Attachment No. 2 – Final Change Order

Change Order No. 1
 Date: 3/8/2024

Project: Jefferson St. WTP Chlorine Feed Improvement

Documentation for Change Order No. 1

Part No: 806-030LSCF

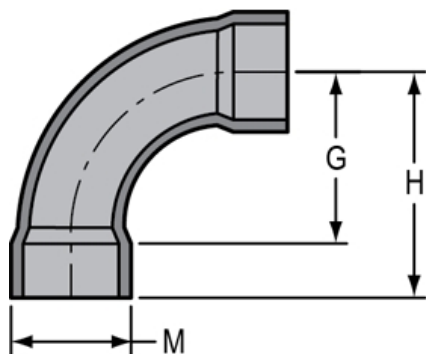
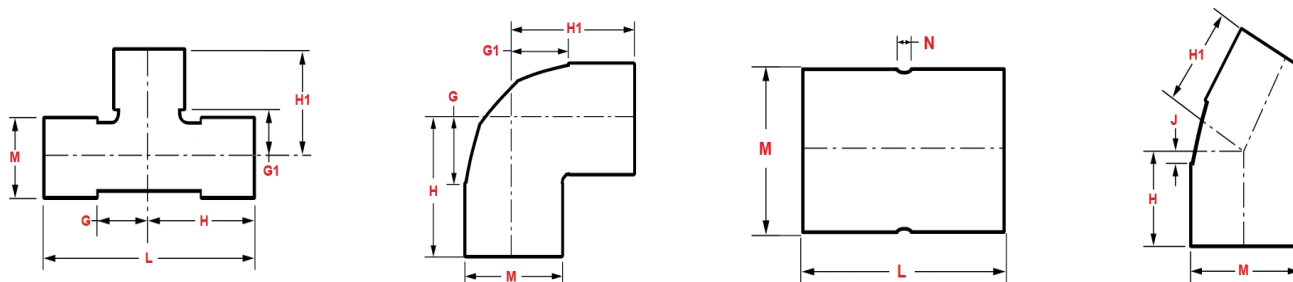
We will proceed with 45's. The long sweeps are double the cost.

See attached Technical Data for the 3" and 4" long sweeps or we can do the two 45 degrees like Mitch mentioned.

We would accept either the soft 90s or the two 45s, as both would reduce back pressure.

COMBINATION AIR RELEASE / DEGASSING VALVE SERIES CARD PROVIDES THREE DIFFERENT VENTING FUNCTIONS

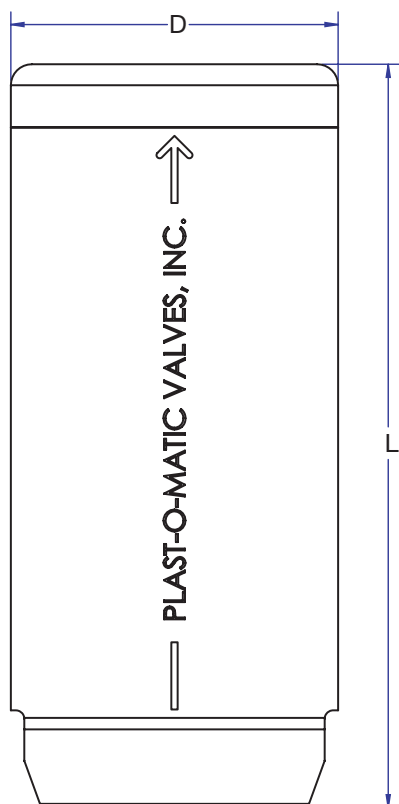
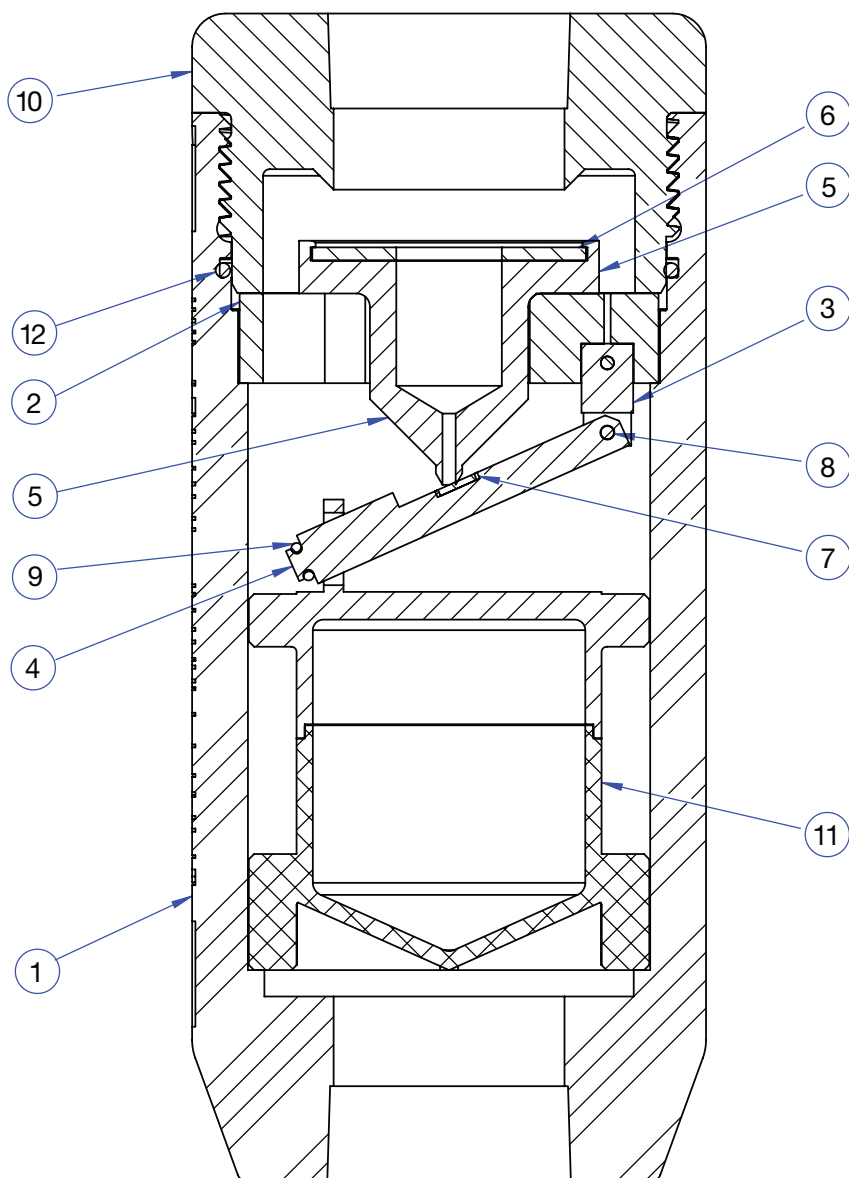
Please confirm the ARV/Degassing valve model number CARD400VT-PV is the request model to price?

Please advise if City wants ARV or a combination ARV/Degassing?

Please utilize one (1) – 4” Combination ARV/Degassing valve. See attached snip below for proposed location.
